Rezoning Application: PD 22-1338
Zoning Hearing Master Date: January 17, 2023
BOCC Land Use Meeting Date: March 7, 2023

APPLICATION NUMBER: PD 22-1338

AGENCY REVIEW COMMENT SHEET

Re: Victory Apartments @ Riverbend
PD 22-1338
Folio 39021-0000
39016-0200
39016-0120
39020-0000
39025-0000
39023-0000
39018-0000
39019-0000
39029-0000

8.0 PROPOSED SITE PLAN (FULL)

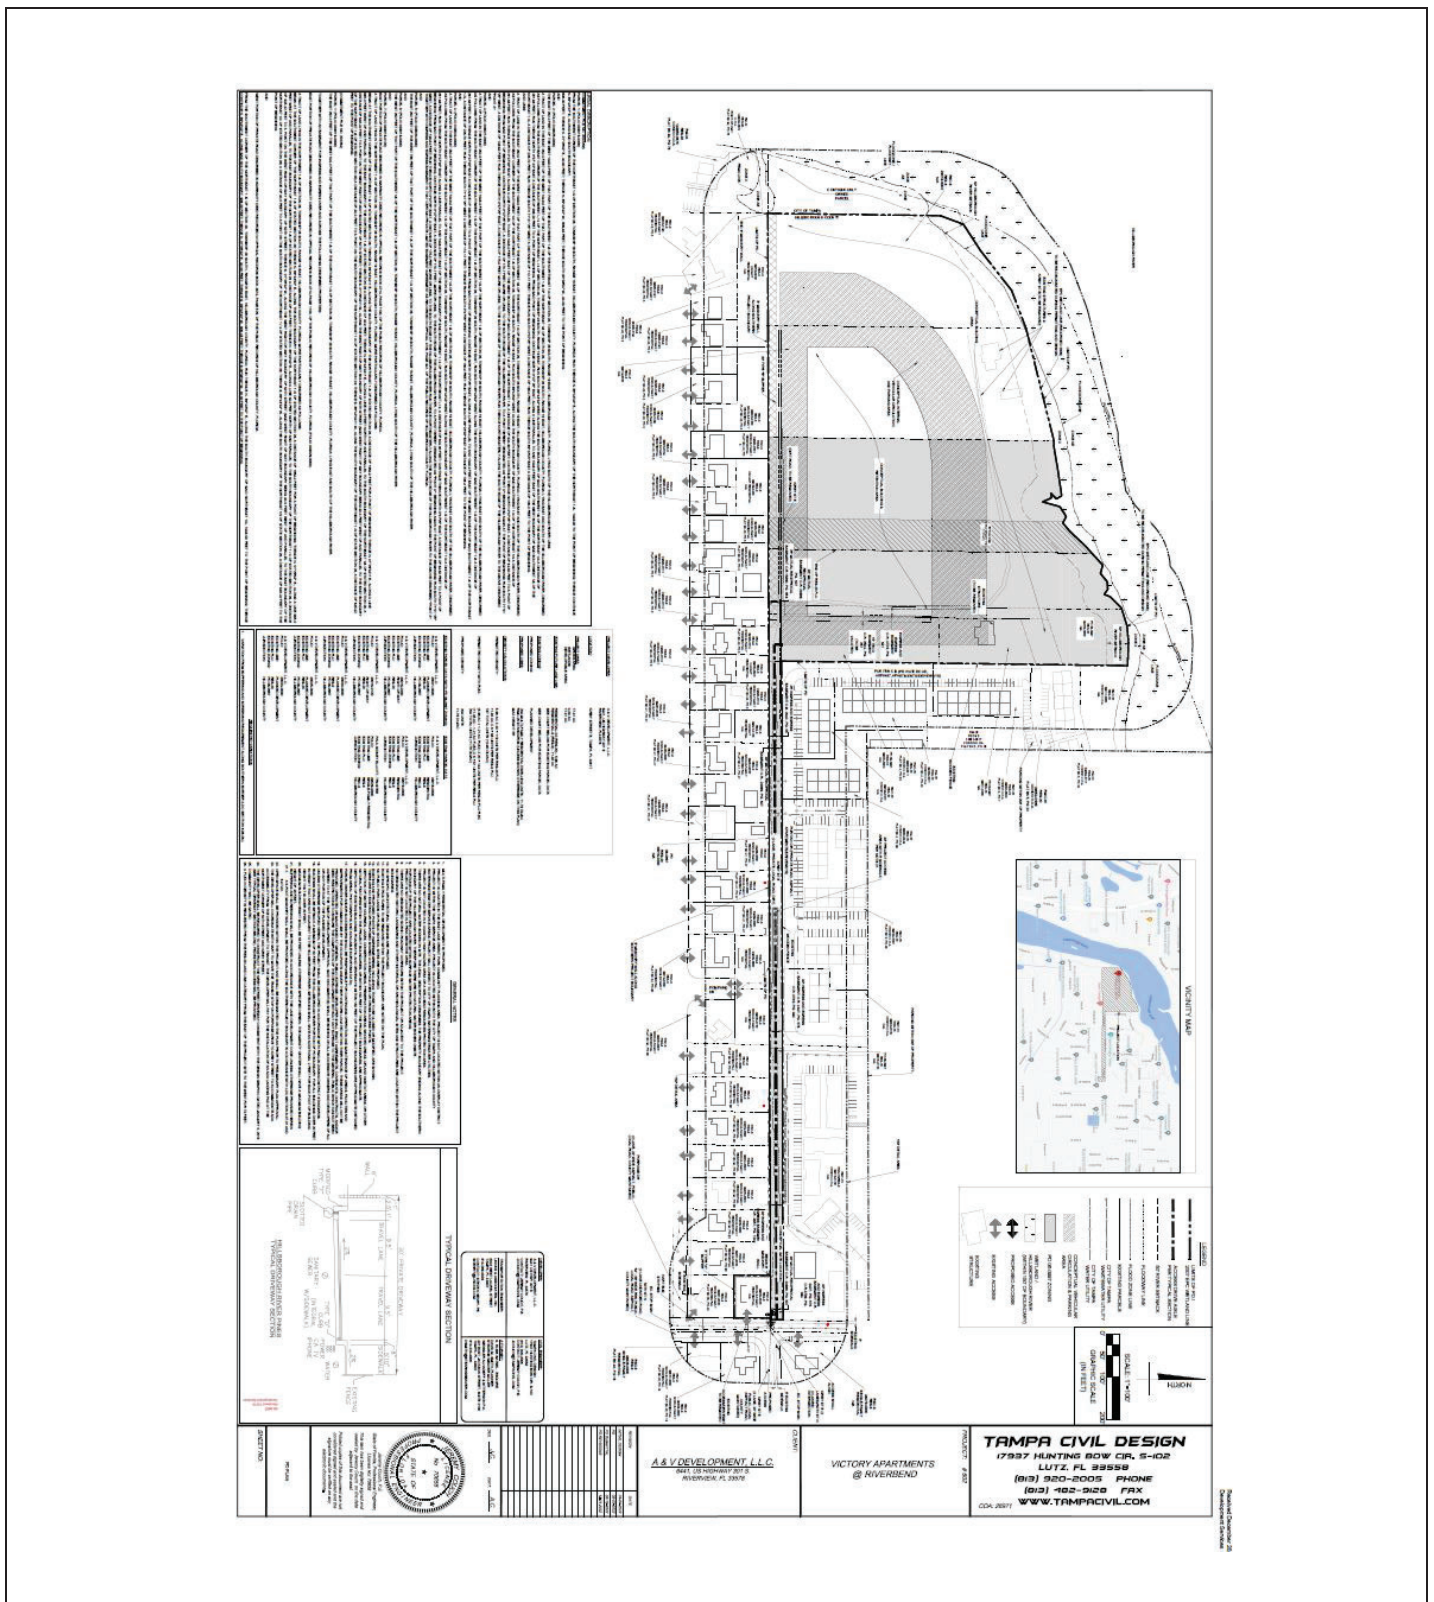
Prior to PD site plan certification, the applicant shall revise the PD site plan to:

- Add a note that states “Parking shall be provided per LDC.”
- Add a note that states “Sidewalks to be provided per LDC.”

**LOCAL URBAN ROADS
(2 LANE UNDIVIDED)
TYPICAL SECTION**

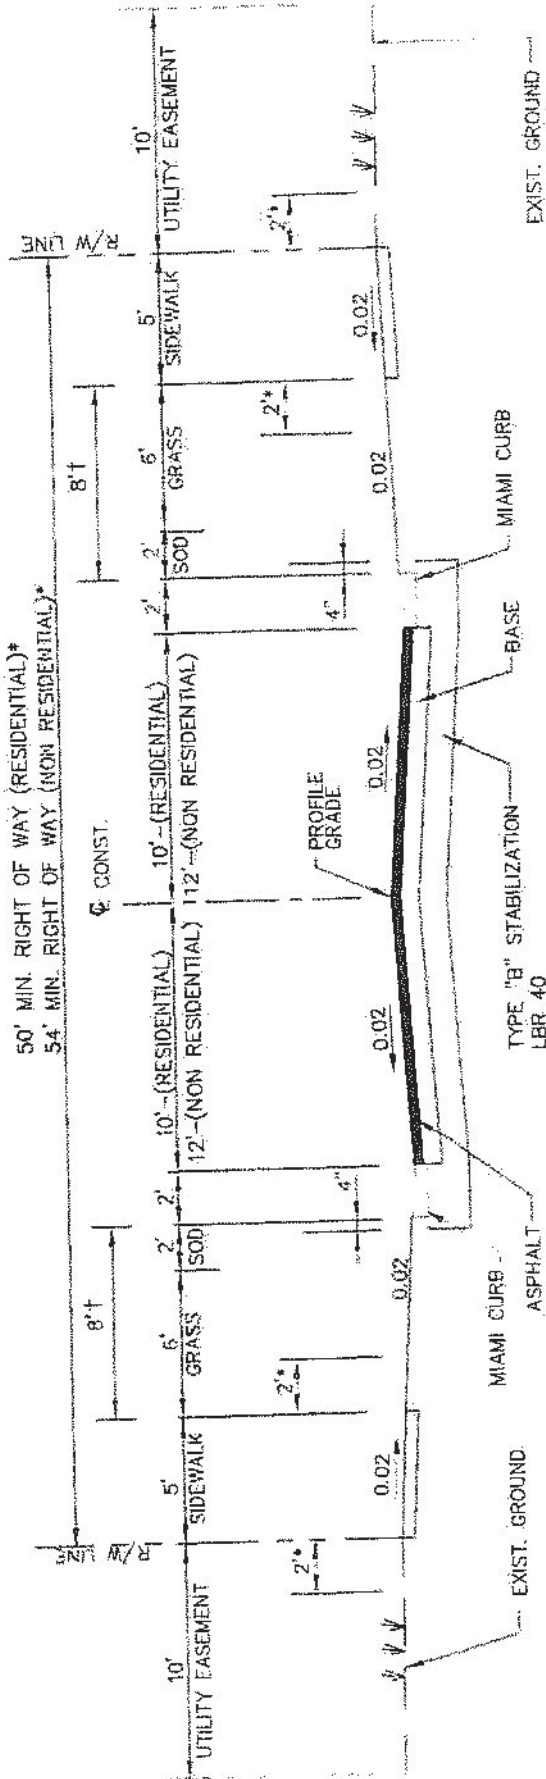
The request is to waive the requirement to improve 50th Street (between the project access and Sligh Avenue) to current County TS-3 standards, the standards for which are found within the Hillsborough County Transportation Technical Manual. The specific waivers are as follows:

1. Miami Curb – There is intermittent curb along the roadway
2. Sidewalk – There is intermittent sidewalk on the east side of the roadway

Adding the miami curb and sidewalk would be an unreasonable burden on the applicant for the following reasons:

1. 50th Street is an established residential street
2. There are a number of speed bumps along the roadway to slow traffic
3. The subject rezoning is not increasing the number of approved residential dwelling units
4. The property has limited frontage along 50th Street

There is continuous sidewalk on the west side of 50th Street which is on the same side of the roadway as the project. In addition, there are a number of speed bumps along the roadway to slow traffic and improve the safety of the roadway. Therefore, the variance would not be detrimental to the public health, safety and welfare.

- If PD 22-1338 is approved, the County Engineer will approve a Section 6.04.02.B. Administrative Variance (dated December 14, 2022) from the Section 6.04.03.L Hillsborough County Land Development Code (LDC) requirement to improve the roadway to current County standards. The Administrative Variance was found approvable by the County Engineer (on December 29, 2022). If the rezoning is approved, the County Engineer will approve the above referenced Administrative Variance Request, upon which the developer will not be required to improve 50th Street to county standard.

50th Street is a substandard road. The land development code indicates that a developer would need to improve the road up to county standards unless an Administrative Variance is submitted and found approvable. The applicant's Engineer of Record (EOR) submitted a Section 6.04.02.B. Administrative Variance Request (dated December 14, 2022) Section 6.04.03.L Hillsborough County Land Development Code (LDC) requirement to improve the roadway to current County standards. The Administrative Variance was found approvable by the County Engineer (on December 29, 2022). If the rezoning is approved, the County Engineer will approve the above referenced Administrative Variance Request, upon which the developer will not be required to improve 50th Street to county standard.
